Open issues on the 1000m link specification Draft 1.0

Dieter Schicketanz consultant
Reutlingen University

Return loss 146.7.1.3

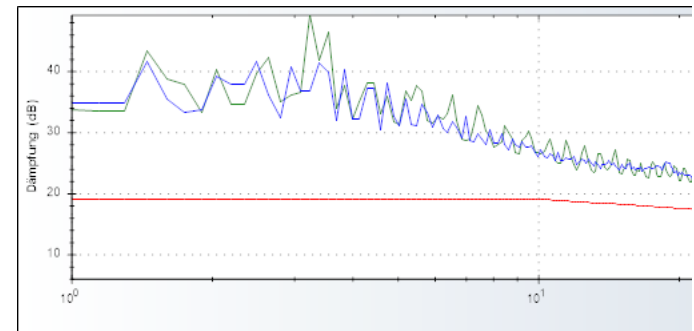
Return loss was presented first time mid 2016 by Fritsche Schicketanz and the values at 20 MHz were never looked again.

At the meantime measurements were done and most show that at 20 MHz the limit does not follow measurements (450m AWG18 cable 6m cord).

It is therefore proposed to relax the RI values at 20 MHz. It would match also most other IEEE links and cabling channels.

Add to equation 146-3

- $10 < f \leq 20$ MHz
- $RI(f) = 24 - 5\log(f)$
